GROUP CLI	MODEL 2014~2015MY Soul (PS)
	NUMBER 030	DATE February 2016
TECHNICAL SERVICE BULLETIN		
SUBJECT: UNEVEN WINDSHIELD DEFROSTER PERFORMANCE

This bulletin provides the procedure to install vent clips on some 2014~2015MY Soul (PS) vehicles, produced from July 21, 2013 through April 5, 2015, which may exhibit uneven windshield defroster performance. Follow the procedure outlined in this bulletin to install two (2) clips onto the center dash vents to resolve the concern.

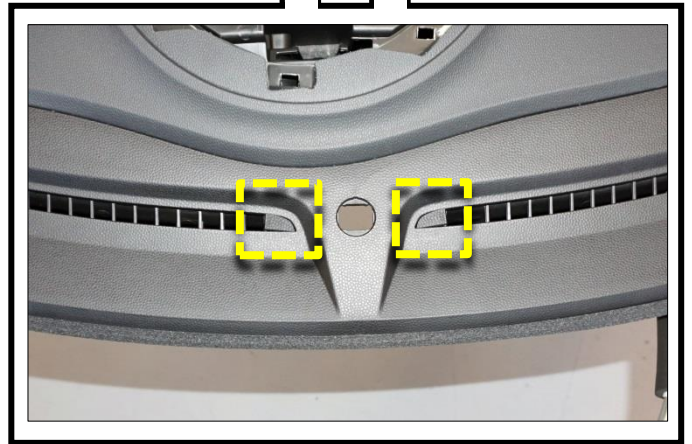
2. Install the left and right vent clips onto the two innermost openings of the dash vents, as shown. **NOTE: dash shown removed to improve illustration clarity only.**

Make sure to avoid dropping the clips into the vents.
